IT Help Desk - Received 7/1/18 TML

Building 200 3rd floor

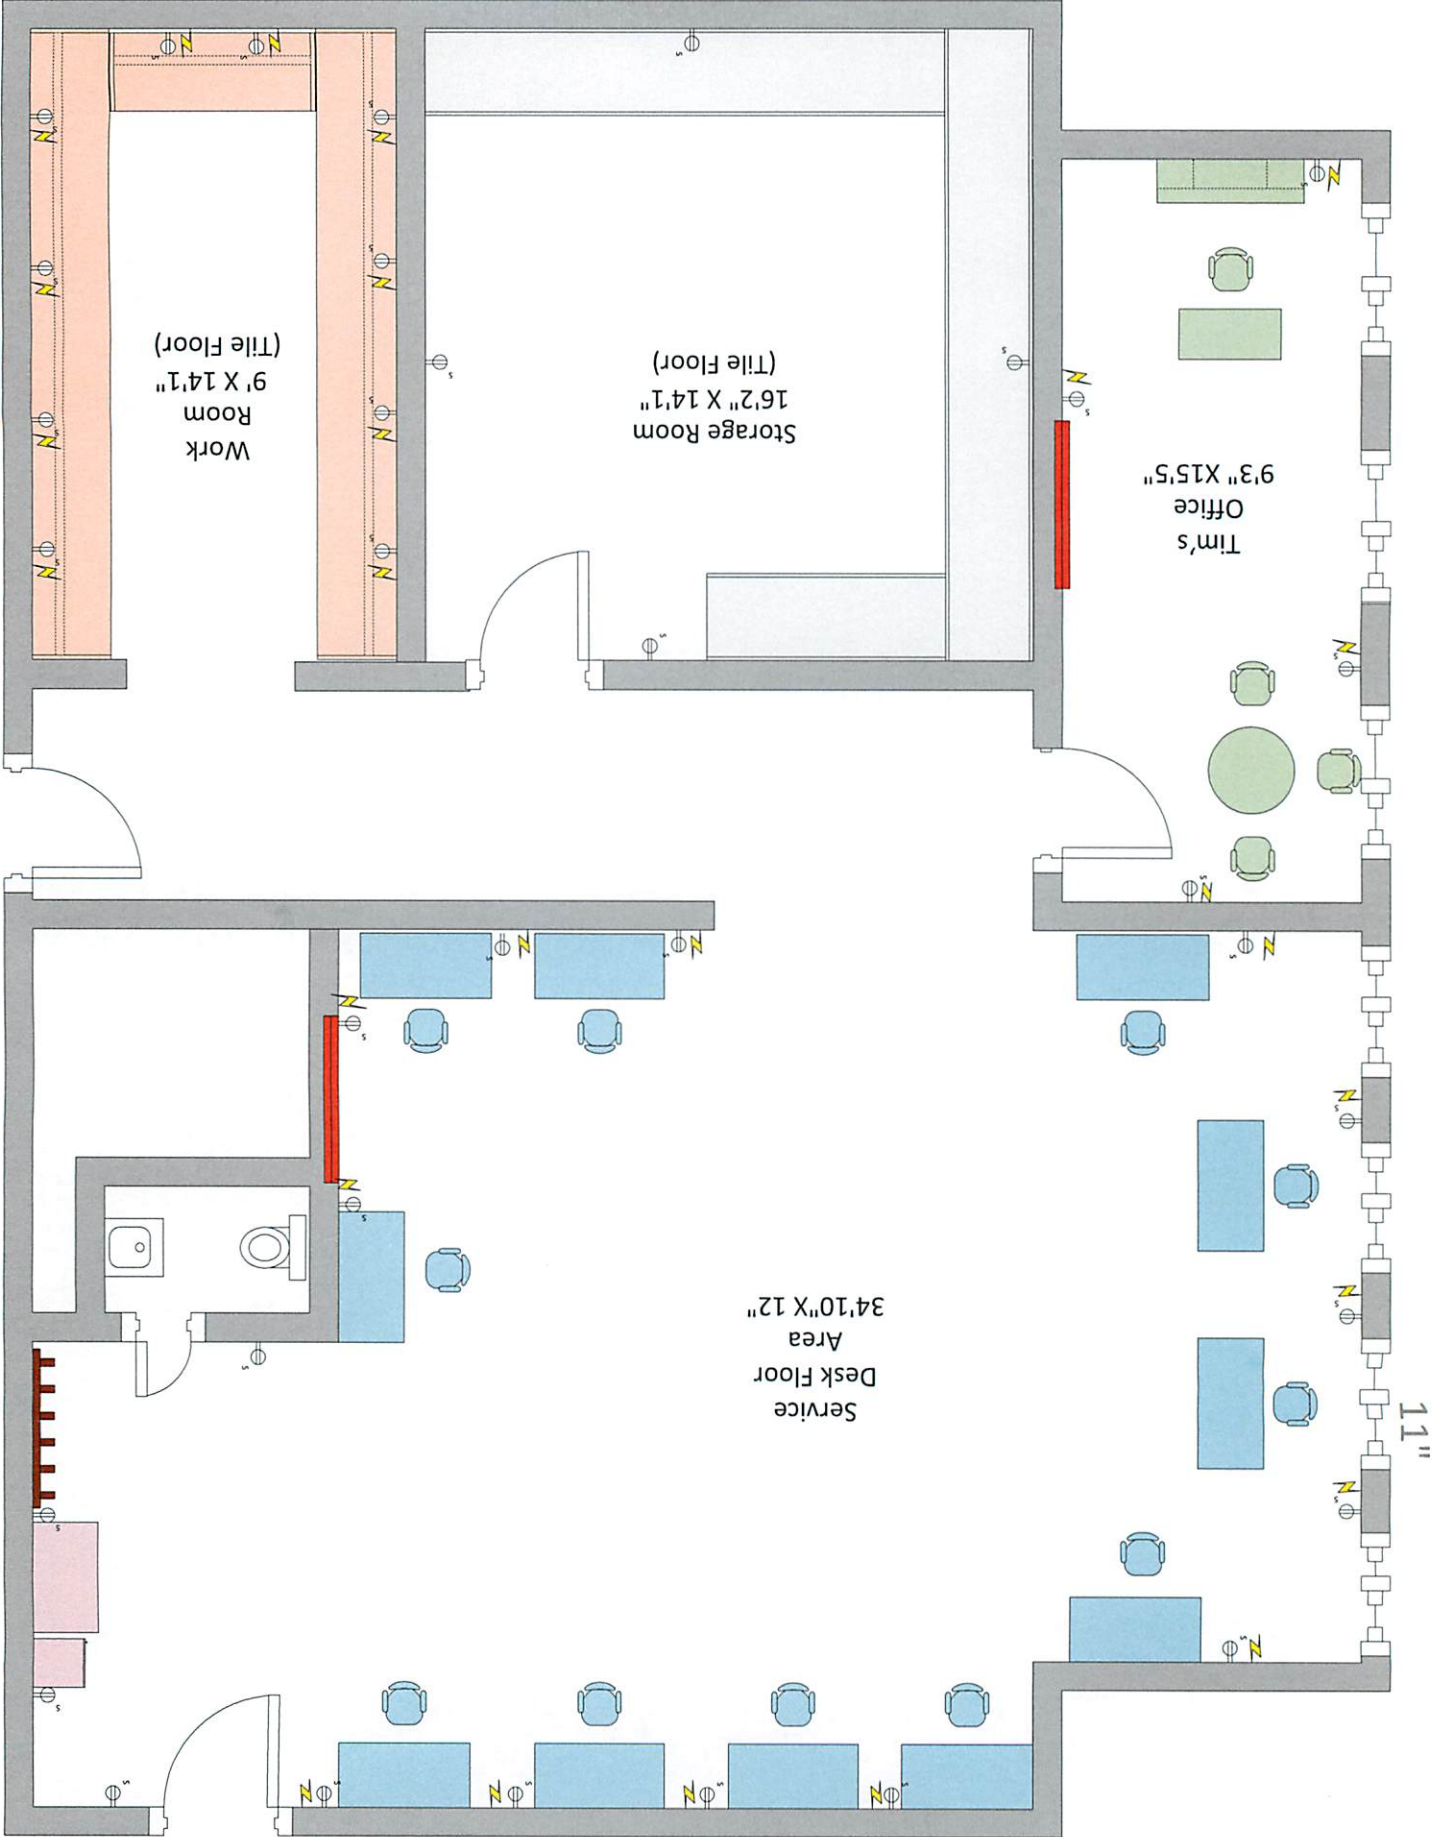
- COPIER
- ICE MACHINE
- COMM ~~CLOSET~~ CLOSET 50A
- ~~RECEPTACLE~~ (2) DEDICATED IN KITCHEN

- 1) Any circuits in Center Island in Break room? **NO**
- 2) Any dedicated receptacles required?
- 3) Can you please provide power requirements for the ice machine? **NOT AT THIS TIME.**

- 4) The power requirements for the Comm. Closet? Allow for quad receptacles? **YES**
- 5) The power requirements for Laptop in the Conf. Room? Allow for duplex receptacle? **YES**

- 6) Does the power for the ceiling projector and the Smart Board need to be dedicated? **NO**
- 7) Does the 50A receptacle for the UPS go in the comm./data closet or the work room? **COMM ROOM, ITS FOR THE PHONE UPS**

- 8) Do the power and data outlets in Care Management need to be dedicated? **NO**
- 9) The fire alarm contact number for Hillard has been disconnected. Can you please provide a current telephone number? **HILKER SYSTEMS, INC. 757 549 9123**

- 10) We assume no HVAC power changes are required. **NO ELEC. REQS. FOR HVAC**

* ALSO ATTACHED IS THE POWER/
COMM PLAN FOR THE IT HELP
DESK SPACE.
